Dammam DRT Sustainable Wetlands and Mangrove Conservation (DD-SWAM)

Validation Report

Title of report	Dammam DRT Sustainable Wetlands and Mangrove Conservation (DD-SWAM)
ID of report	CC IPL2100/ICR/VAL/SWAM/20231228
Client (Project proponent)	Saudi Arabian Oil Co. (Saudi Aramco)
Criteria for validation	<input type="checkbox"/> ICR requirement document v.4 <input checked="" type="checkbox"/> ICR requirement document v.5 <input checked="" type="checkbox"/> ISO 14064-2 <input checked="" type="checkbox"/> Applied methodology, CDM Methodology AR- AM0014: Afforestation and reforestation of degraded mangrove habitats v3.0 ¹ <input type="checkbox"/> Other, please specify.
Date of validation	03/01/2024 to 19/04/2024 (Date of on-site inspection to FVR Preparation)
Version number of this validation report	2.0
Date of version	19/04/2024
Prepared by	Carbon Check (India) Private Limited (CC IPL)
Contact	Address: Registered Office: 2071/38, 2nd Floor, Nawala, Karol Bagh, New Delhi - 110005 Corporate off: Unit No. 1701, Logix City Centre Office Tower, Plot No. BW-58, Sector 32 Noida, Uttar Pradesh – 201301, India Telephone: +911204373114 Email: info@carboncheck.co.in URL: www.carboncheck.co.in

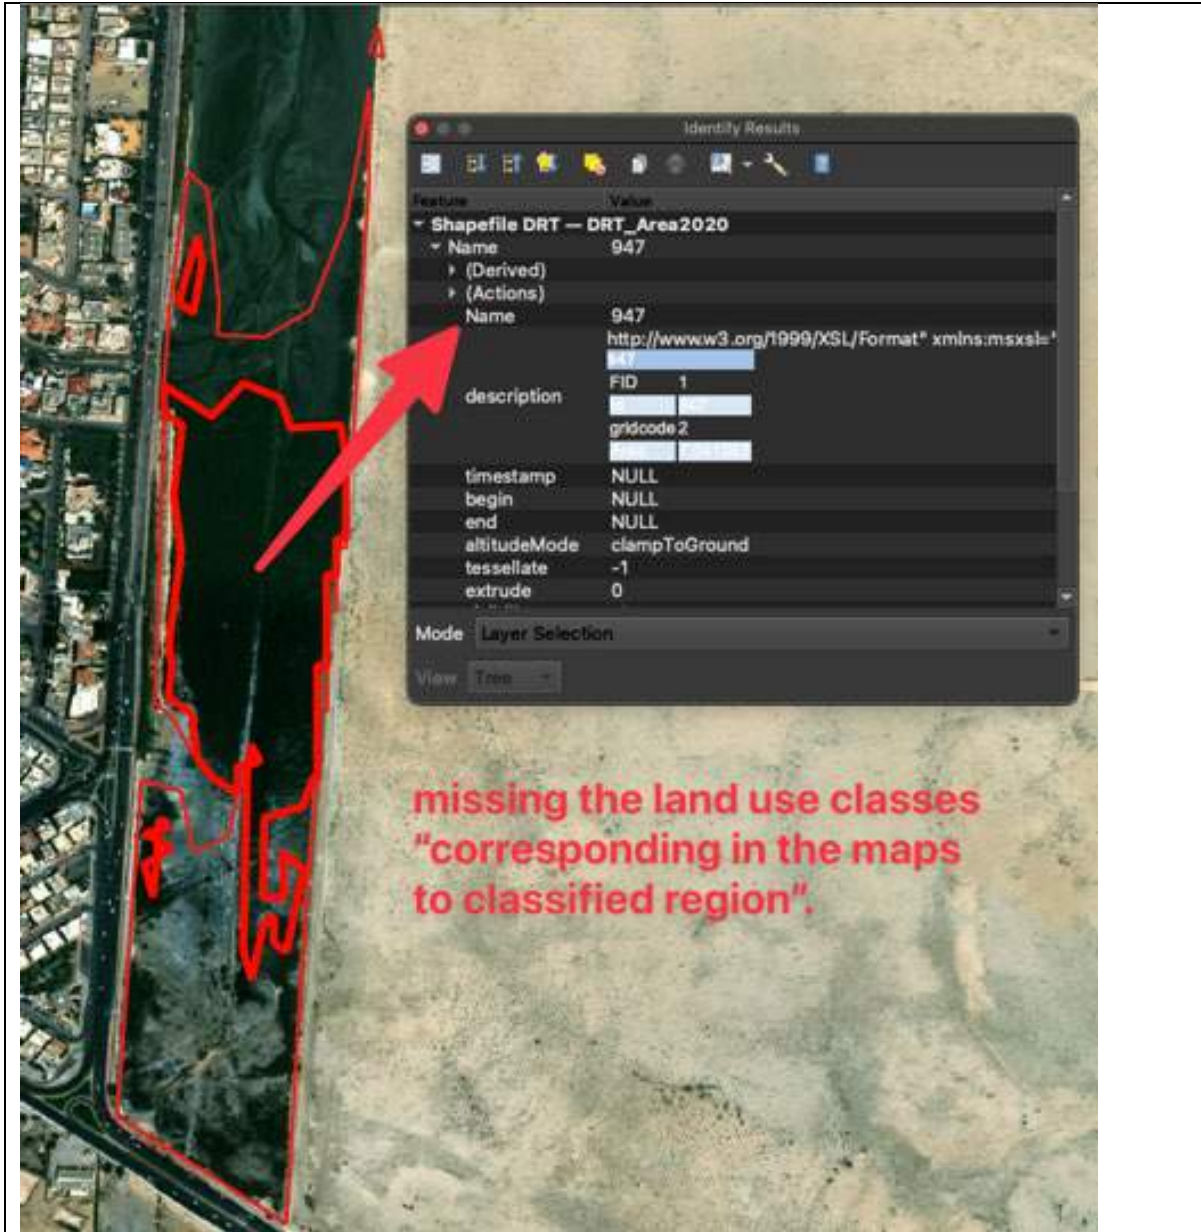
While reviewing the KML files provided, VVB has observed that the KML files exhibit inconsistencies detailed as follow:

1. The provided KML files exhibit inconsistency in the spatial extensions of 'DRT Shapefile.kmz (2014)' and 'Shapefile DRT.kmz (2020)' differ from each other. Please refer to the figure below for a visual comparison."

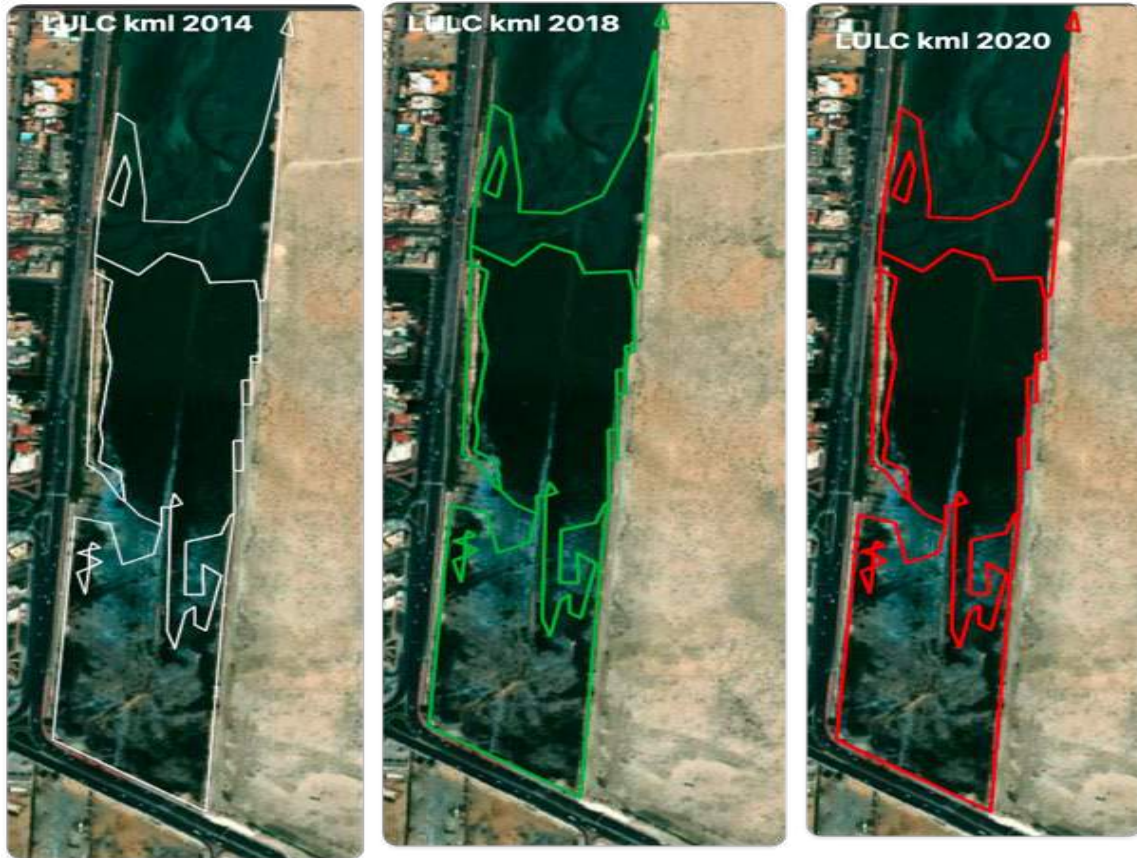
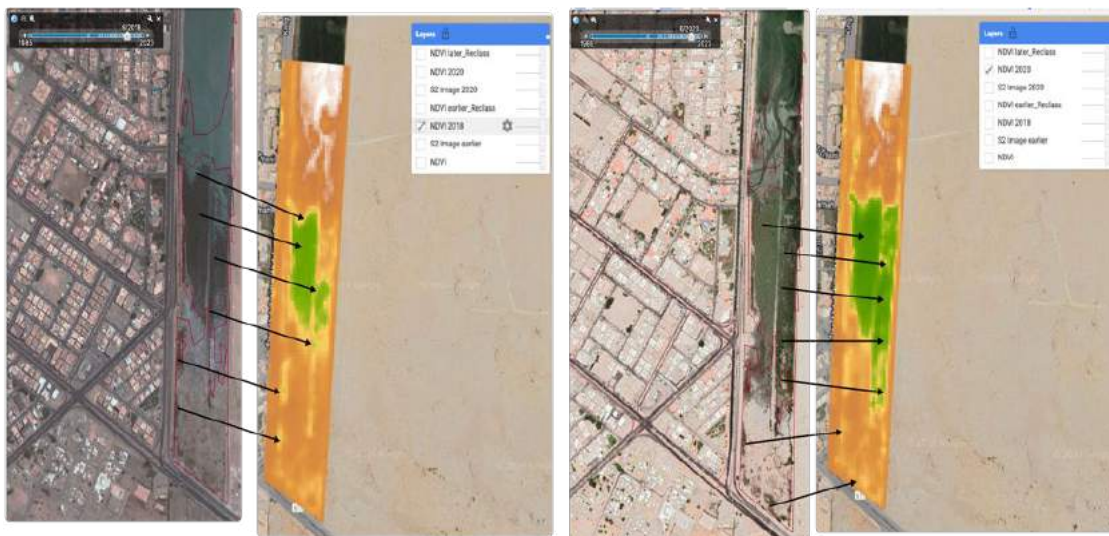
After reviewing the KML files provided by PP, VVB observed that the KML files for LULC 2014-2018-2020 remain

unchanged throughout the analysed period. For a clearer understanding, please refer to the figure below.

However, analysis of the project area, utilizing NDVI calculations derived from Sentinel-2 imagery, reveals a significant change in Mangrove areas between 2018 and 2020. This observation was further corroborated by comparing the NDVI data with corresponding Google Earth images from the same timeframe. Refer to the figure below for visual representation.

<p>PP shall provide supporting document for LULC delineation considering the LULC definition fitted to the project scale. PP must provide LULC satellite image files in easily readable formats, such as GeoTIFF, KML, KMZ, Shapefile, etc.</p> <p>CL is still open.</p>	
Round 3	
Project participant response	Date: 08/04/2024
Documentation provided by project participant	
Revised KML files have been provided.	
VVB assessment	Date: 09/04/2024
<p>VVB based on the review of the revised KML files concludes that the project proponent expects only to restore the degraded mangrove habitat area identified within the project boundary, through plantation activity.</p> <p>To avoid further discrepancy further discrepancy regarding project area and land use cover in current scenario PP has now excluded the area under existing mangrove vegetation from the project boundary and thereby aligns with the ICR guideline and requirement of methodology applied AR-AM0014 (section 2.2.)</p> <p>Based on the review of files and evidence provided by PP, VVB confirms that kml for LULC (2014,2018 & 2020) and the literature provided, are enough evidence to prove the mangrove degradation in and around the project area.</p> <p>VVB confirms that the revised documentation is valid and acceptable for the subject ICR project.</p> <p>The CL has been closed.</p>
